**TAILING TEST PLOTS ANNUAL REPORT
REPORT-NO. 1**

**PHELPS DODGE TYRONE INC.
AND
CHINO MINES COMPANY**

2.0 RESPONSES TO COMMENTS ON AS-BUILT REPORT

In a November 8, 2007 letter, the MMD and the NMED provided comments on the report titled, “*As-Built Report-Cover, Erosion, and Revegetation Test Plot Study-Tailing Test Plots.*” The MMD and NMED conditionally approved the report pending satisfactory responses to the conditions listed below. This section details responses to the Agencies comments.

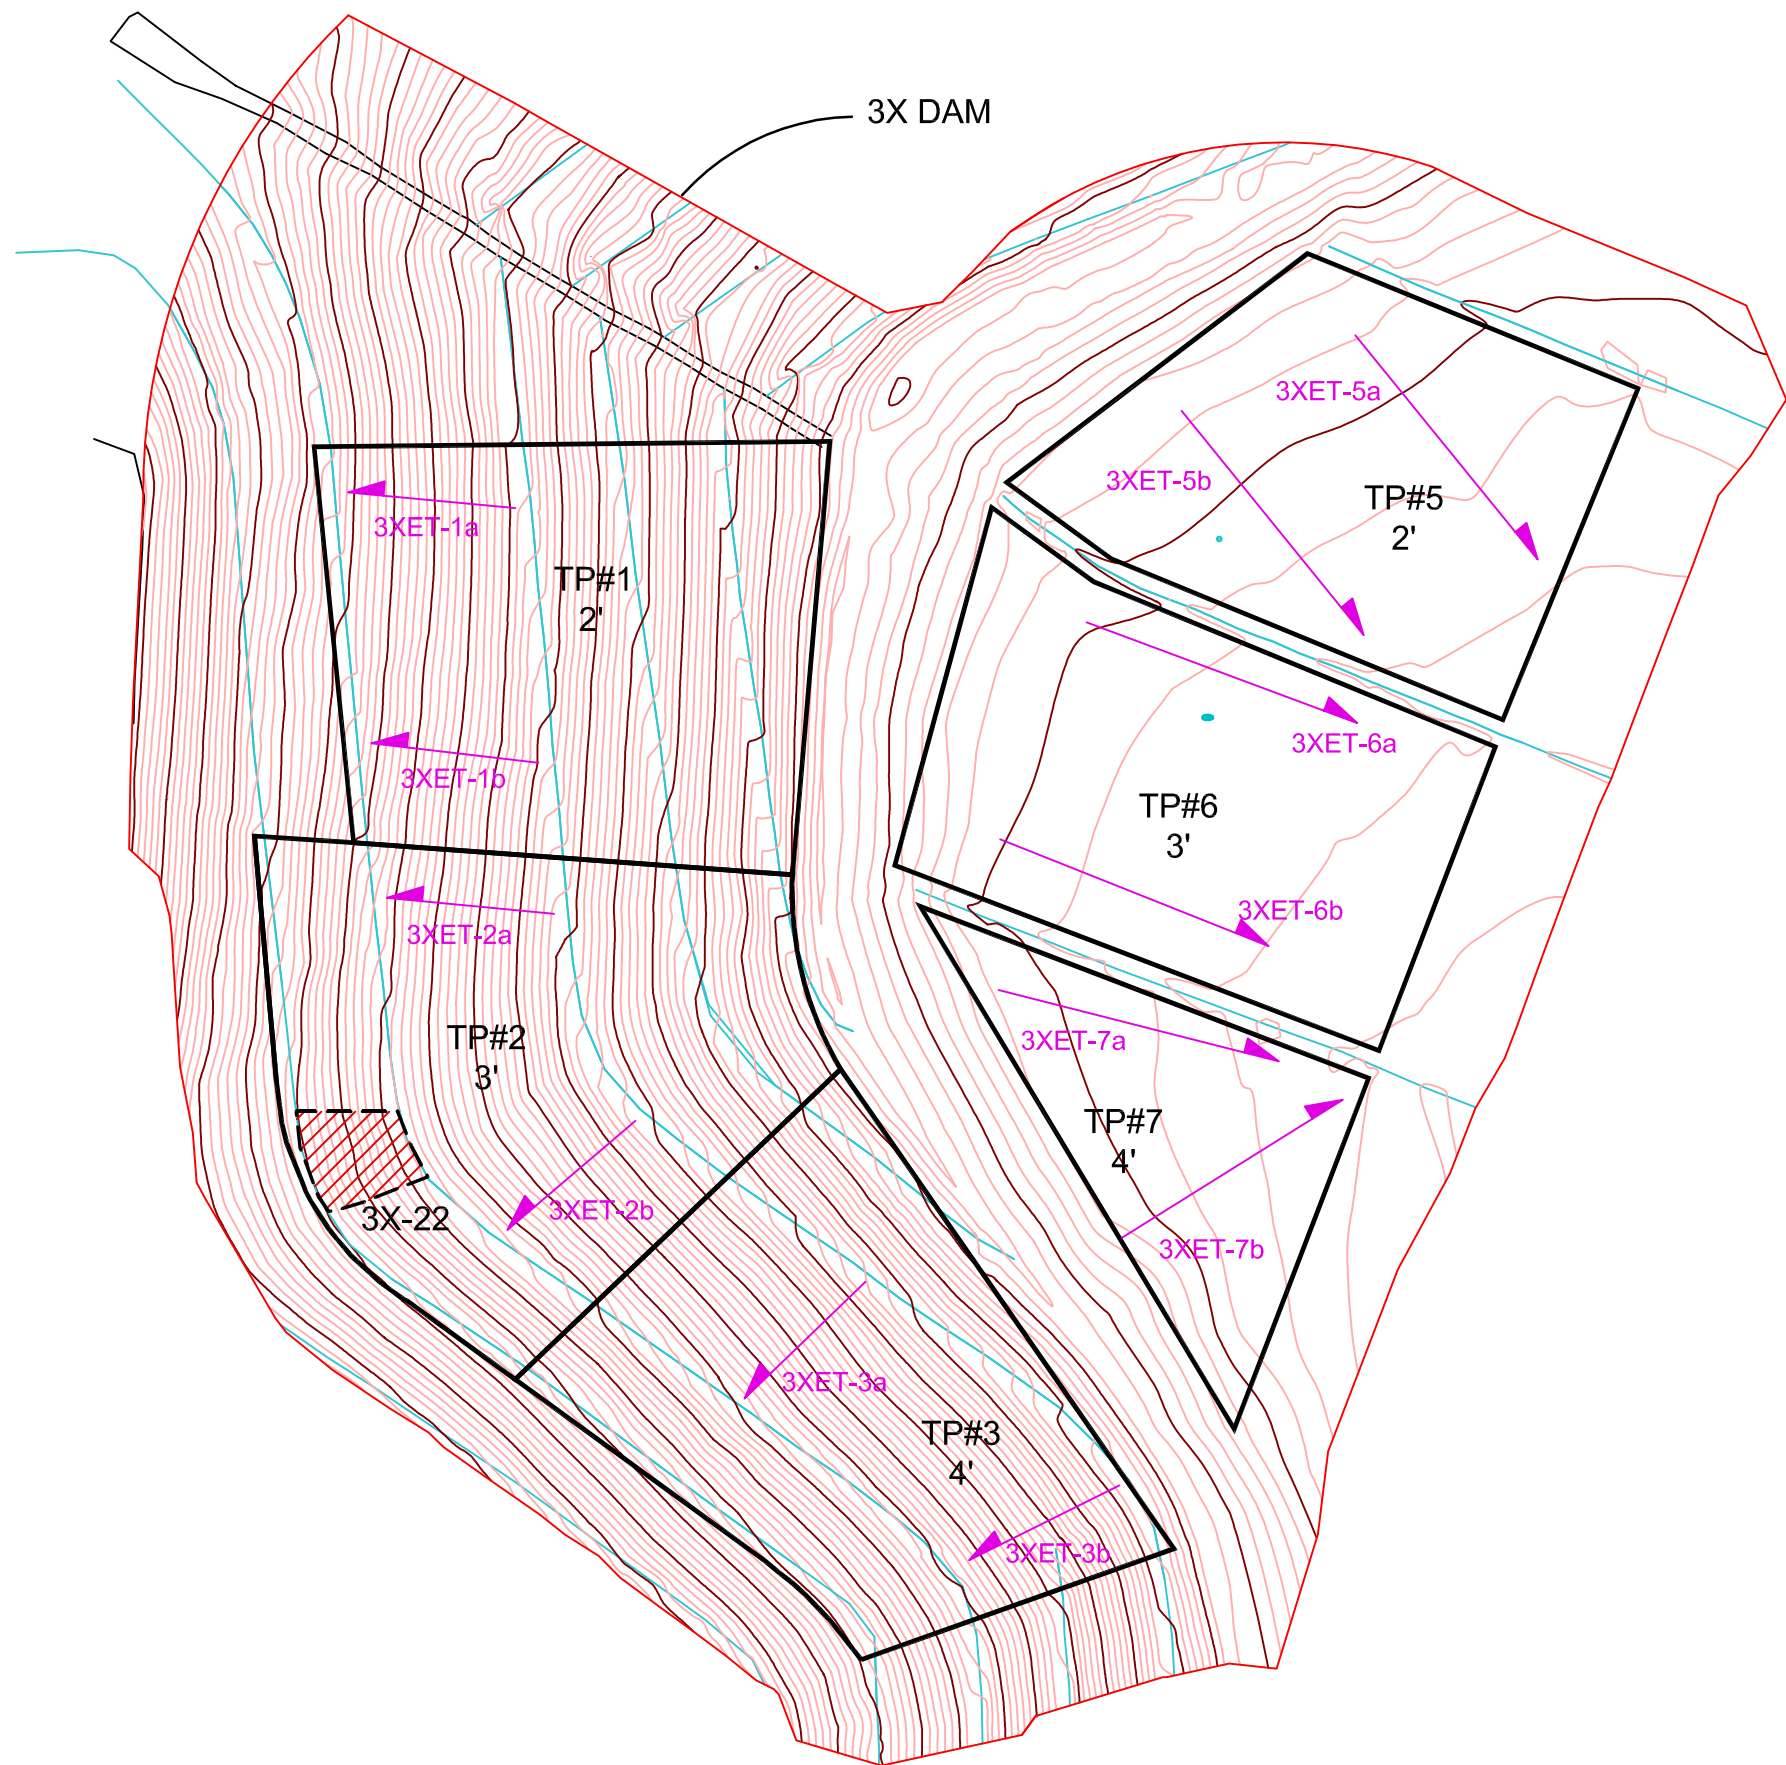
PDTI must include updated maps with the addition of erosion monitoring instrumentation (i.e., pin locations), the repaired area on the slope of the No. 3X Dam (TP#1), and the subsidence areas associated with any lysimeters.

Figure 2 is an updated map showing the approximate location of the erosion transects, corrective action area on Dam 3X and approximate lysimeter subsidence zones.

PROJECT	PHELPS DODGE TYRONE INC. TAILING TEST PLOTS GRANT COUNTY, NEW MEXICO			
TITLE	SLOPE PROFILES AND FERTILIZER TREATMENT AREAS			
PROJECT No.	053-2365	FILE No.	3X TP ASBUILT CS	
DESIGN	LM	01/15/07	SCALE	AS SHOWN
CADD	CM	01/31/07	REV.	0
CHECK	DR	01/31/07	PLATE 1	
REVIEW	LM	01/31/07

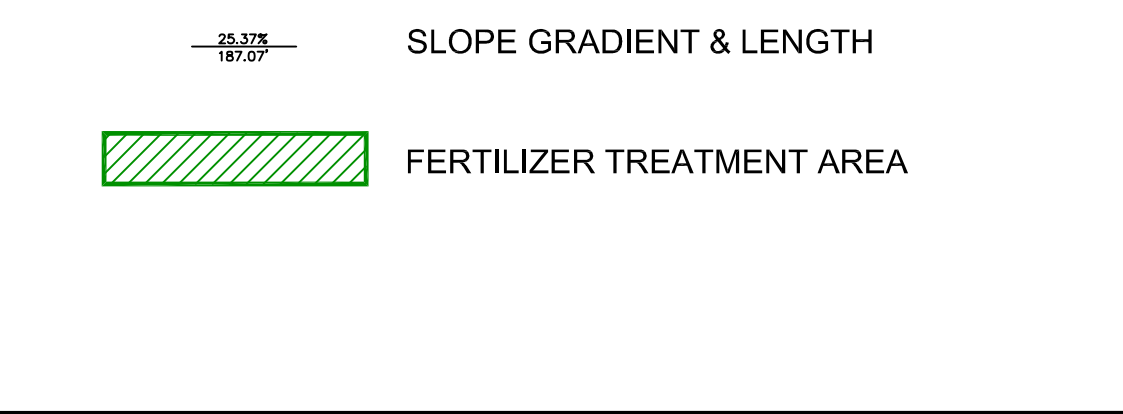
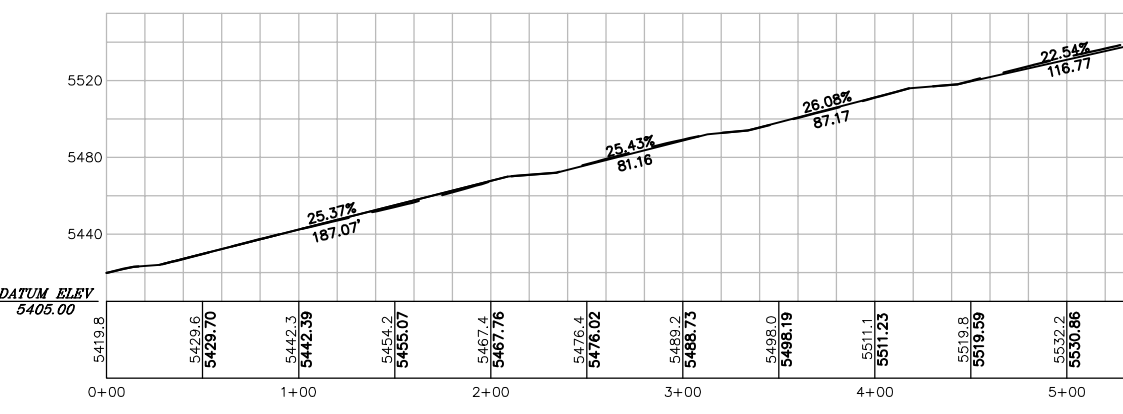
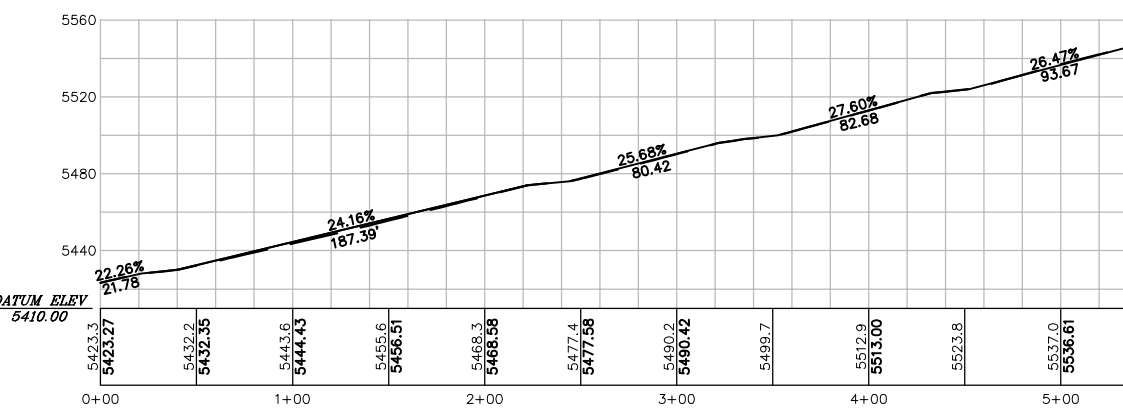
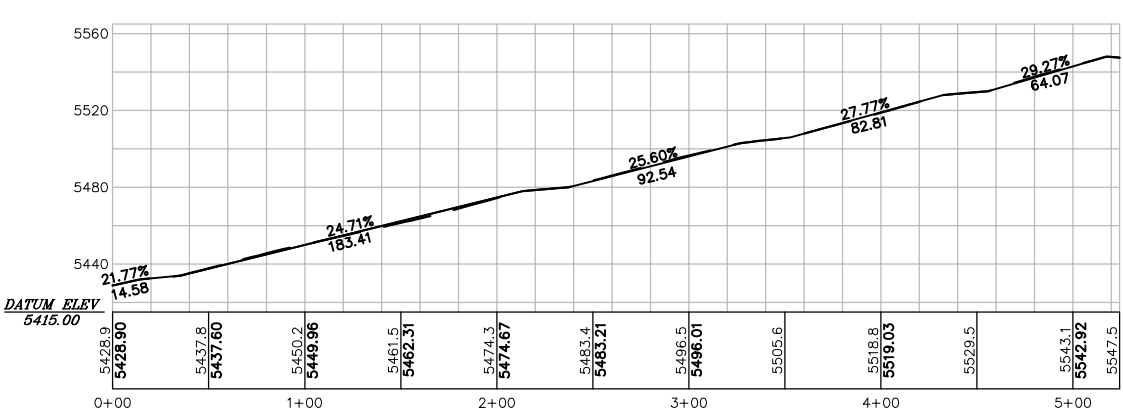
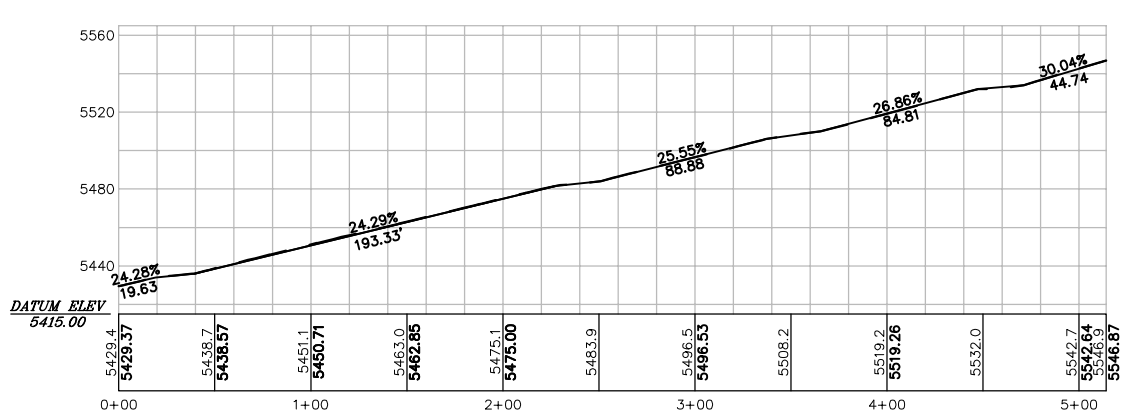
In Section 3.2 and Plate 1, there is some indication that the sloped test plots were flatter and shorter in length than is defined in the permit language. PDTI must explain the causes for the change in grade from the proposed design and if these are due to construction limitations.

The test plots were constructed as part of the overall reclamation of Dam 3X. The permits allows for slopes with gradients up to 3:1 on the tailing dams, however, the gradients on Dam 3X are generally shallower than 3:1 and it was not feasible to construct steeper slopes. The final reclamation designs for the test plots were approved by the MMD and NMED as part of the routine review process on Dam 3X.

The slope lengths on the test plots are generally shorter than originally proposed since the designs did not fully consider the slope length reductions associated with the construction of the v-ditches. Plate 1 provides additional cross-sections.
